SFO LONG TERM PARKING GARAGE 2
CIVIC DESIGN REVIEW – Combined phase 2 and 3

June 19, 2017

MODIFIED AREAS

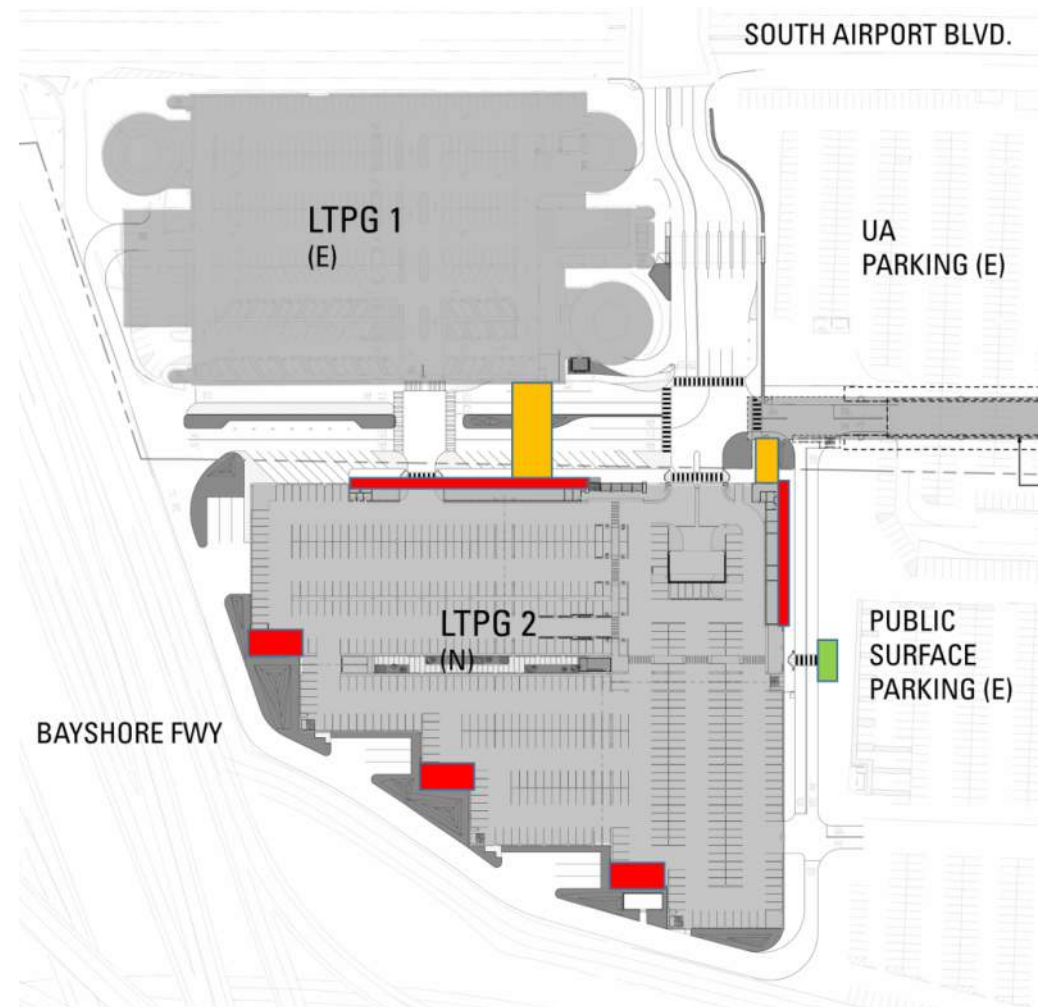
Based on comments from the May 15th 2017 CDR presentation, and the additional input received at the June 6th 2017 informal CDR meeting the team has made modifications to the design to address the committee's concerns. The main areas impacted are highlighted on the adjacent site plan.

Changes include west façade panels, color, vehicular connector, south side landscape and concrete to wall transition at the pedestrian areas.

The natural gray concrete is contrasted by white panels at elevators, entrances, canopies and the west facade

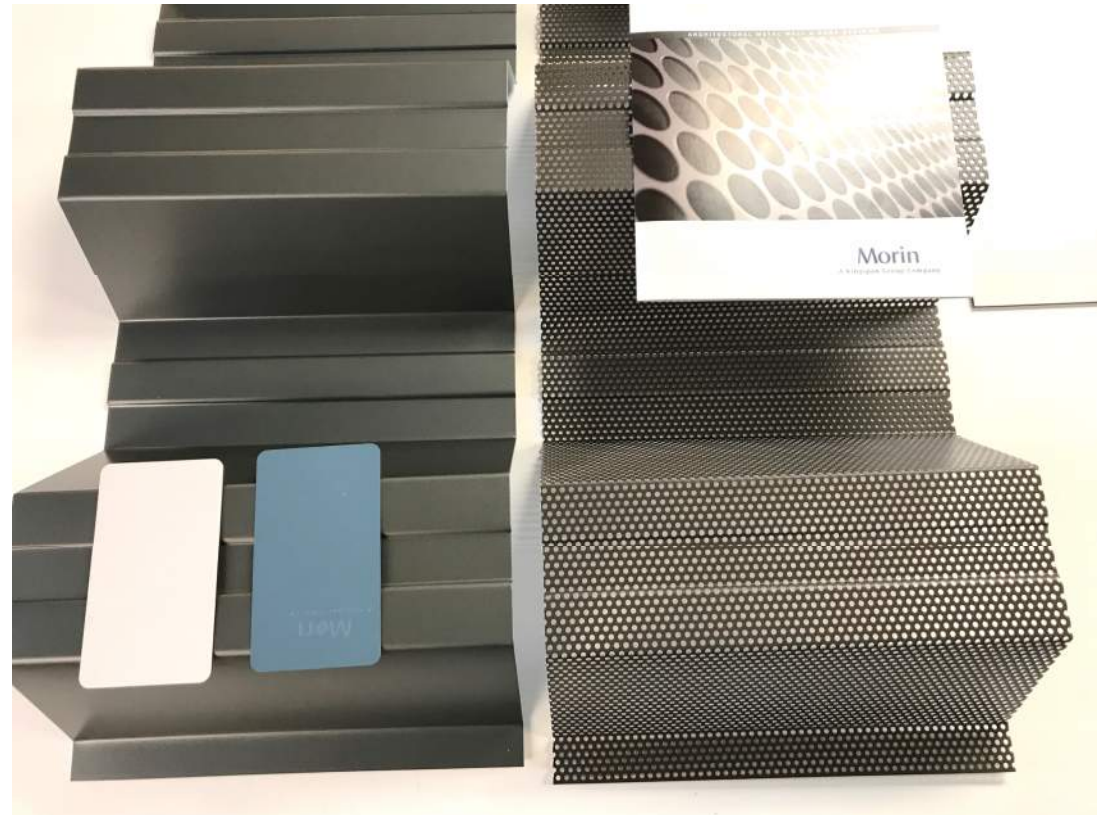
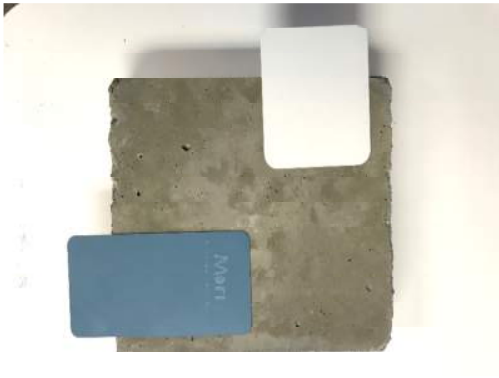
2) The committee encouraged a treatment that would have a civic presence and spoke of the tradition of using white concrete at SFO, which for this design, was a departure from this palette.

The garage uses cast in place concrete with a natural gray color. SFO now avoids standardizing white concrete since experience shows it can become quite dirty. Current environmental efforts encourage increased use of fly-ash, which counteracts a white appearance. The garage concrete includes a minimum of 30% fly-ash admixture following Parksmart recommendation. The design seeks to create a contrast between the white aluminum panels and the natural gray concrete frame.

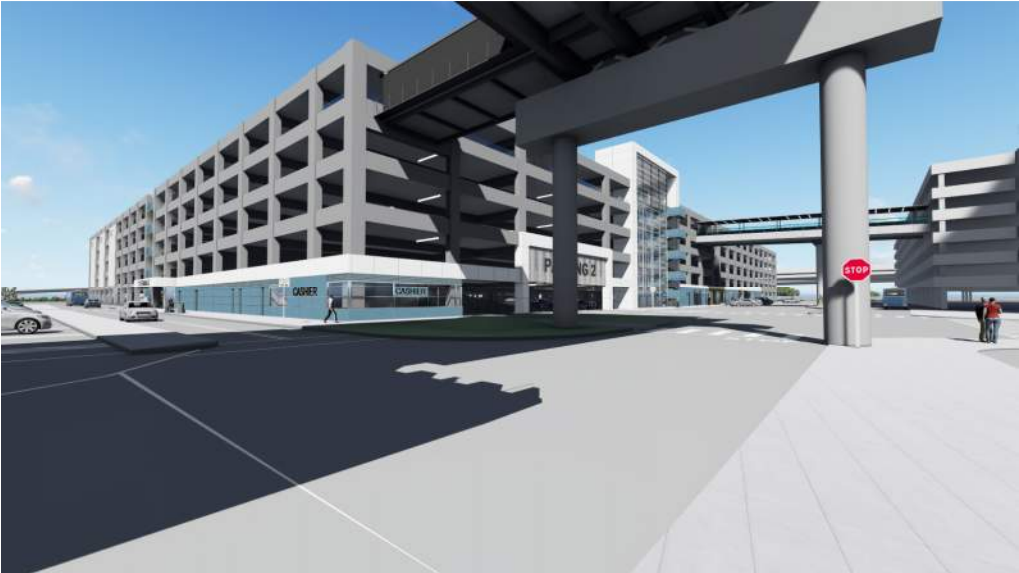
4) *The Committee suggested that the team revisit the color palette of the structure.*

At public areas of the building a color treatment is proposed. This includes all the panelized walls at the amenities, cashier, bus drop-off and the public stairs. Shown in this presentation is a blue theme for the entire building.

Other color variations are currently under consideration by SFO and are represented below. The selected final color will become the theme of the design and needs to relate to the other buildings and functions on the campus and the airport at large.

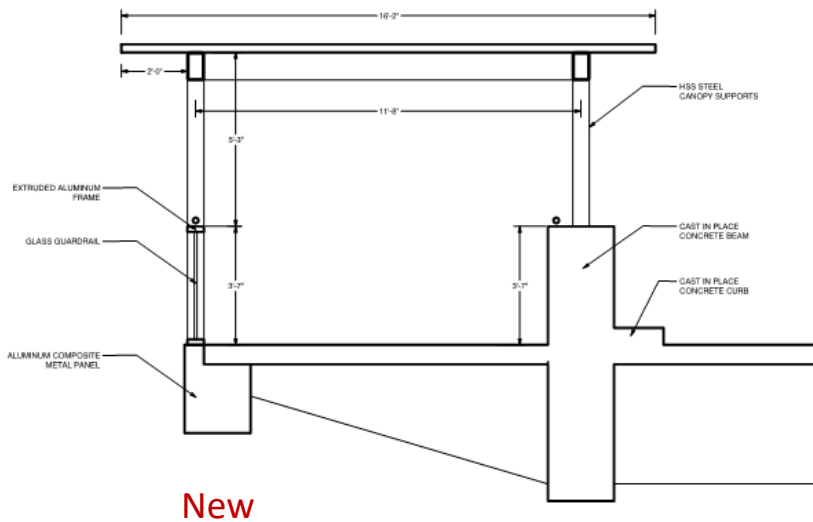
5) In regards to the landscape, the Committee thought the team did a good job but would like to see more greenery where people would be.

Additional planting at the south side of the building is envisioned at the connection to the side entrance and waiting area, close to the bus drop-off zone. This will be coordinated with the lot DD improvement after both projects (ATE & LTPG2) are completed and this parking area can be restored.

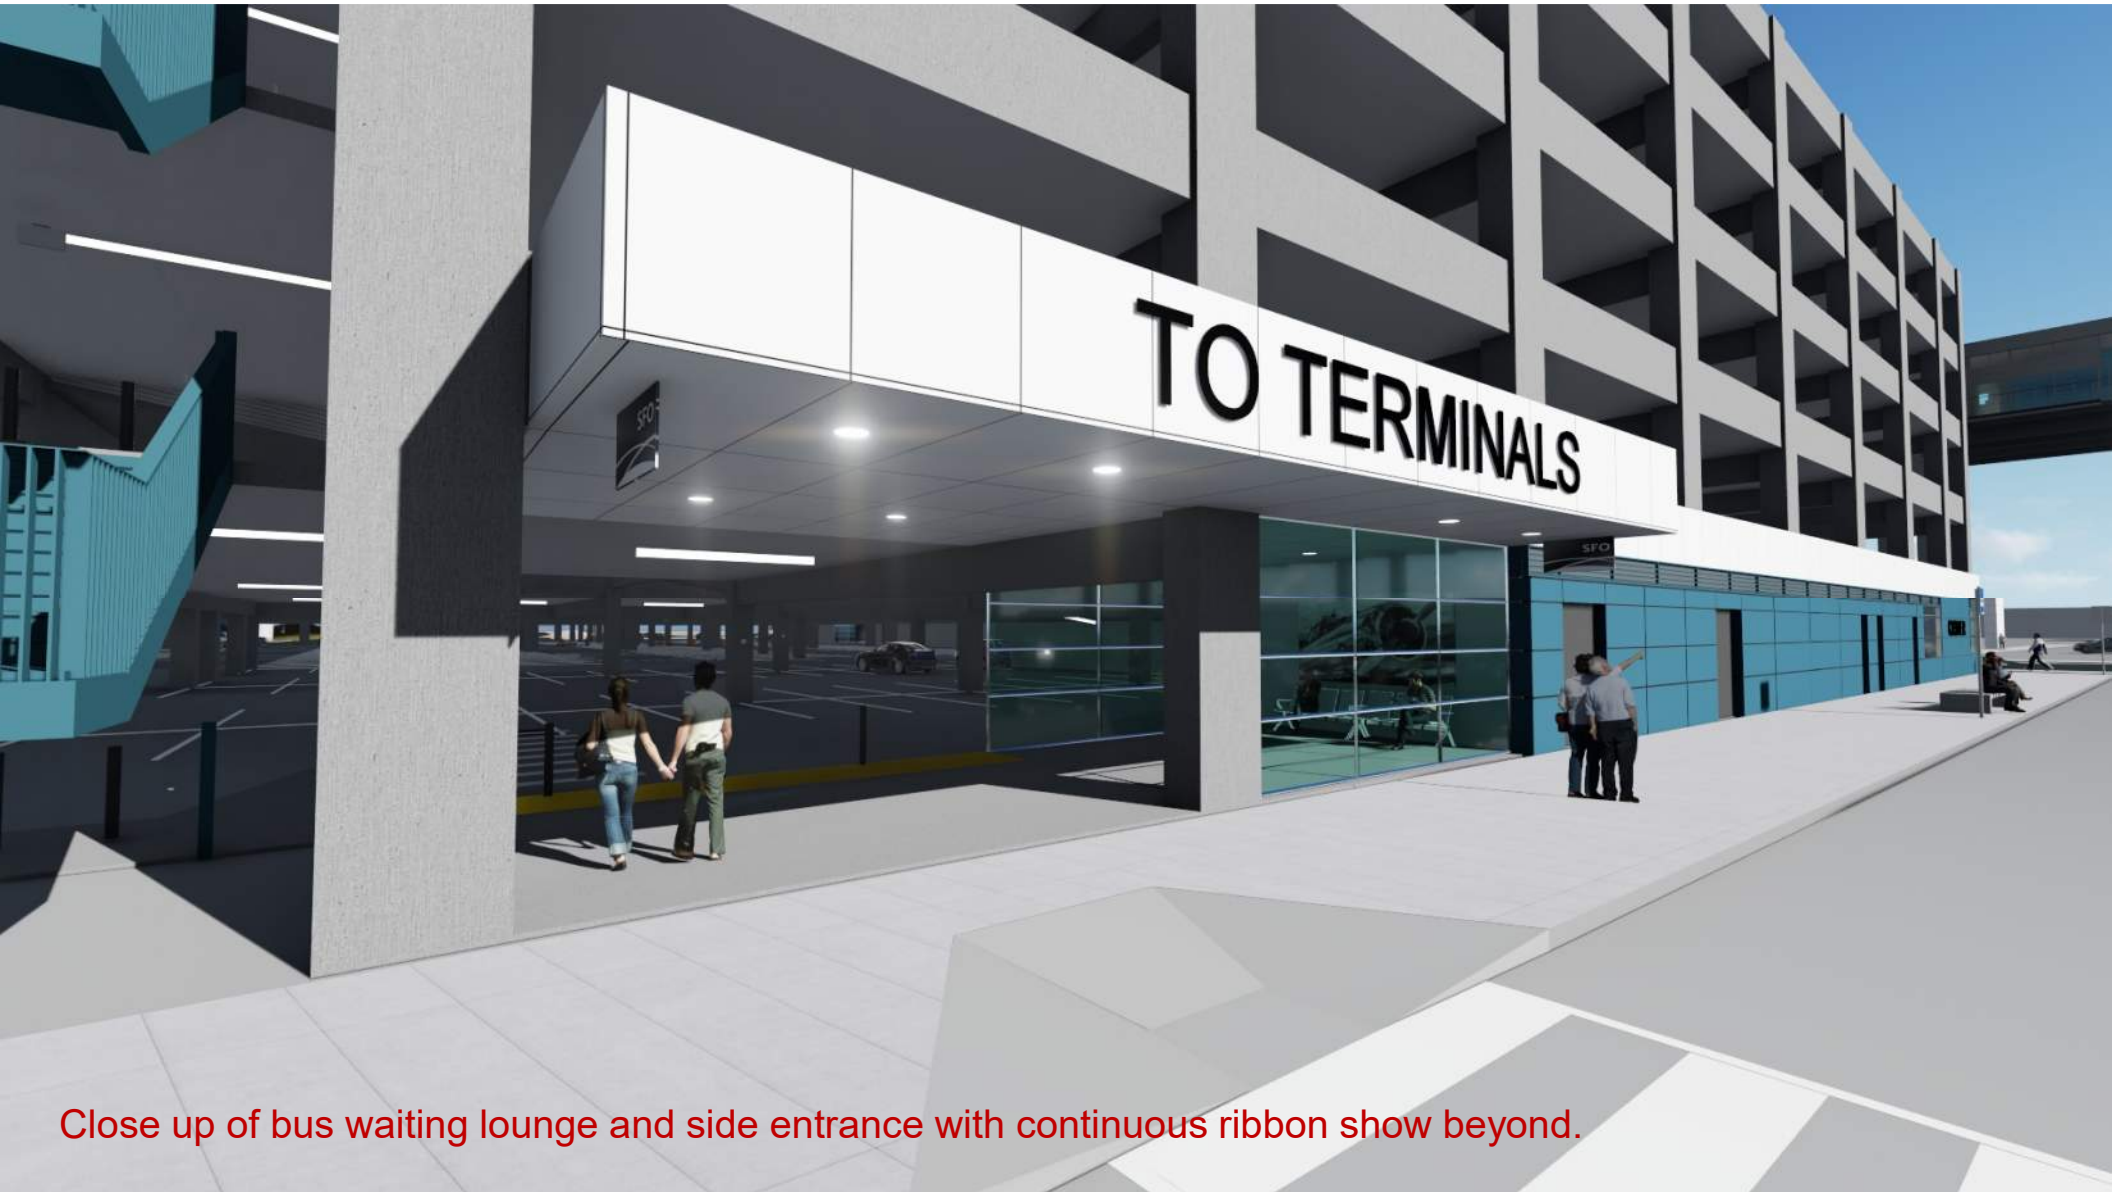
6) Furthermore, the committee asked that the project team reconsider the two walking bridges, so that both would have a more unified and consistent design.

Both bridges will have similar paneling and exterior glass even though they function differently. The AirTrain bridge is enclosed with full height glass and paneling top and bottom, the vehicular bridge will feature guardrail height glass and paneling at the bottom but be open at the top. Materials and bay sizes will match.

Areas where the design, materials and bay sizes will match between the enclosed and the open bridge are highlighted in red on the image to the right. Below is shown a close up of the vehicular bridge detailing, suggesting a white panel and window wall guardrail.
